## REQUEST

Current Zoning: R-3 (single family residential)  
Proposed Zoning: R-8MF(CD) (multi-family residential, conditional)

## SUMMARY OF PETITION

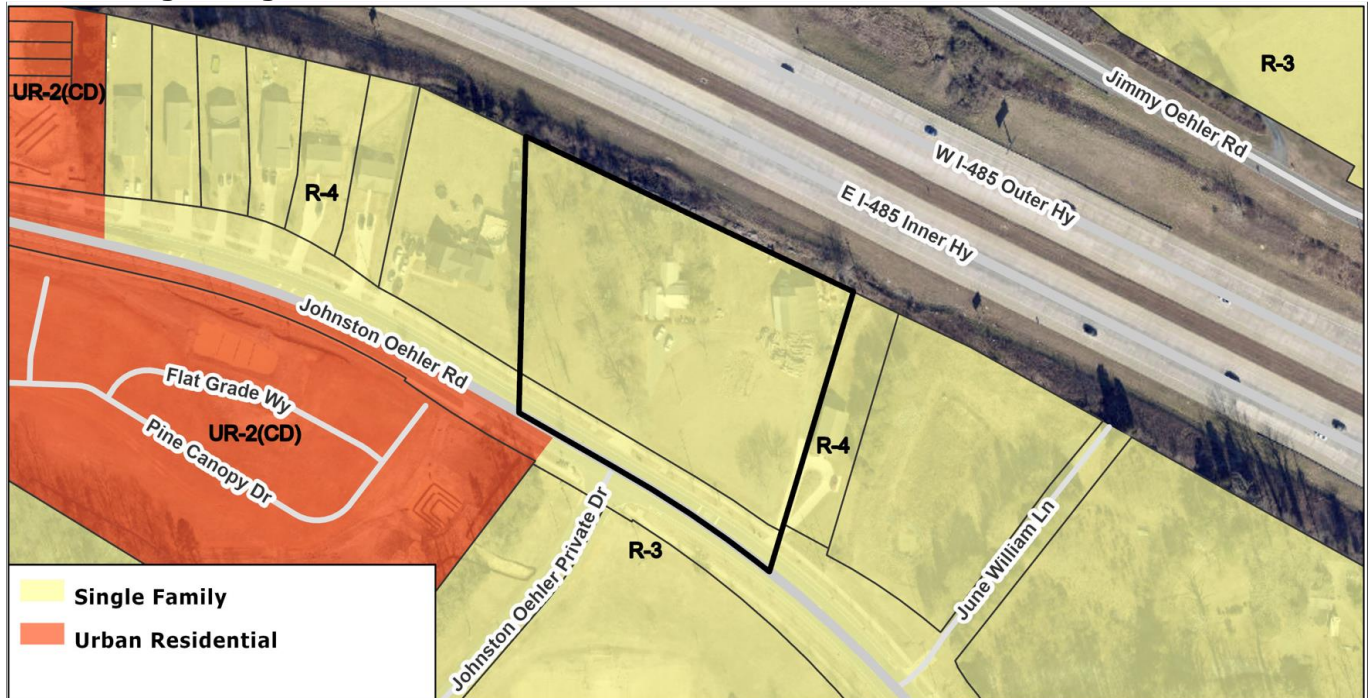
1. ~~Part of what is shown would not qualify as protected tree save. This will either need to be adjusted to protect existing trees and/or additional tree save would be required.~~ **Update:** Petitioner must show acceptable tree save on rezoning plan. Replanted tree save is not an available option. **Addressed**

2. ~~Please clearly specify unit type (single family detached, single family attached townhomes, or multi-family) on the site plan. Please ensure all notes and data are consistent with respect to type and unit count on all sheets.~~

3. ~~Under Permitted Uses Heading, remove detached if a multi-family use is proposed. If a detached use is proposed all lots must front on a public street. Also provide acreage and lot dimensions for all lots for a detached use. Please ensure all sheets are consistent with respect to information.~~

4. ~~Increase setback to 30 feet along Johnston Oehler Road and along I-485.~~
5. ~~Connect buildings to sidewalk system along Johnston Oehler Road.~~
6. ~~Illustrate parking on site plan.~~

7. ~~**New Comment:** The driveway connection to parcel 02962162 would not be allowed because parcel 02962162 is zoned R-4. Planned multi-family developments cannot be accessed through R-4 zoning.~~

~~Parcel 02962162 would need to be rezoned to a district that allows for Planned multi-family developments to allow for the driveway connection.~~ Addressed
